MIL-PRF-49467A
AMENDMENT 2
15 July 1998
SUPERSEDING
AMENDMENT 1
20 April 1998

CAPACITOR, FIXED, CERAMIC, MULTILAYER, HIGH VOLTAGE
(GENERAL PURPOSE), ESTABLISHED RELIABILITY,
GENERAL SPECIFICATION FOR

This amendment forms part of MIL-PRF-49467A, dated 19 May 1997, and is approved for use by all Departments and Agencies of the Department of Defense.

FIGURE 1. Insulation resistance versus capacitance. "

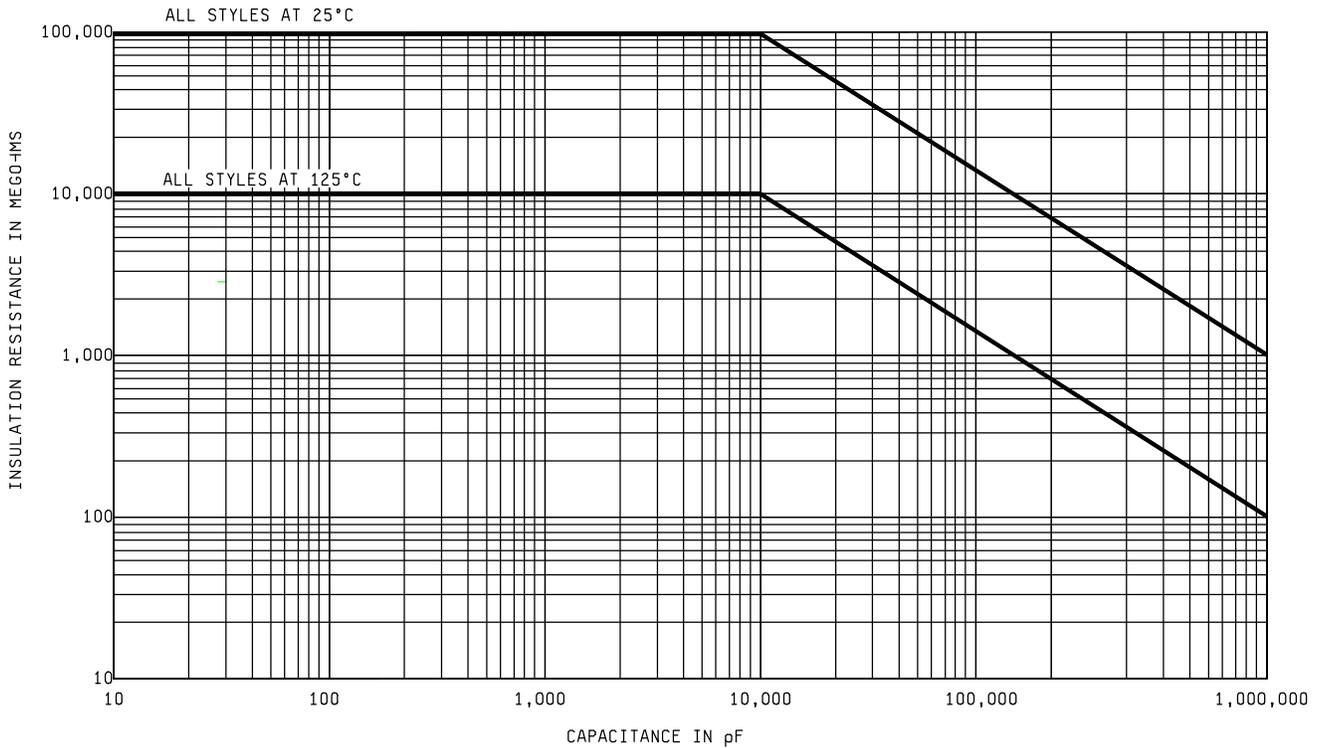
* FIGURE 1, delete and substitute:
